# Application to Revise a Notice of Intention to Commence Small Mining Operations or Exploration RECEIVED

RE: WELLMAN MINERALS CORPORATION – File No. SO 45/0055

RE: WELLMAN MINERALS CORPORATION – UTAH DOGM FILE NO. SO 450055
(BLM UTU 69198/FILE NO. UTM 181718)
MINE NAME: Rocking Chair/Brown Rock #7
Amendment/Revision to Notice of Intention
(Small Mining Operation/Explorations)

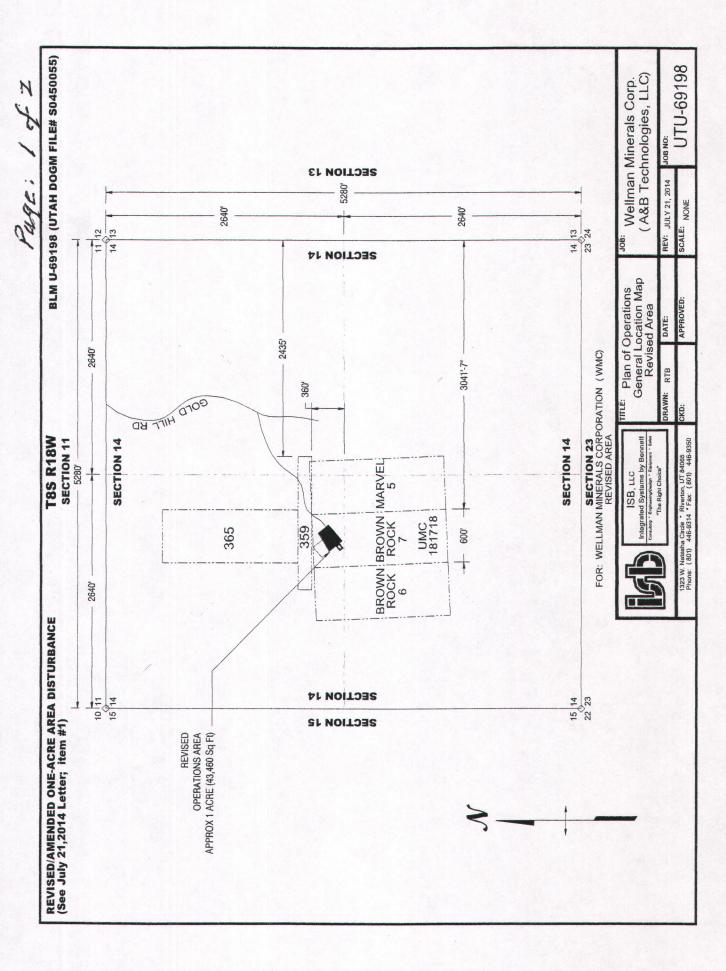
This request includes an amendment/revision to the existing approved <u>Reclamation</u> (<u>disturbance</u>) Area within the Rocking Chair/Brown Rock #7 Mining Claim. The reclamation surety bond presently in place covers a One (1) Acre disturbance area. The proposed (and requested) revision shall also be confined within a One (1) Arce disturbance area. (Please refer to the enclosed area maps.)

The present NOI on file claims an (rectangular) area 150 ft. Wide X 290 ft. Long - One Acre.

This request proposes to trade the (northern portion of the approved on-file area; or area directly "above" the wash area) of the existing approved area for the two sections (as shown on the map(s) immediately to the west and east of the southern portion of the approved area – totaling *One Acre*.

- a) "Southern Portion (including the wash) of the existing approved area 25,875 square feet.
- b) Western attached area (as shown which includes the existing well and fenced area with additional 10 ft. borders on all sides 3,500 square feet.
- c) Eastern attached area (as shown which includes additional overburden area(s) 14,000 square feet.

The approximate total square footage of the three area indicated above are: 43,375 (with allowances to extend to the entire one-acre footage area.
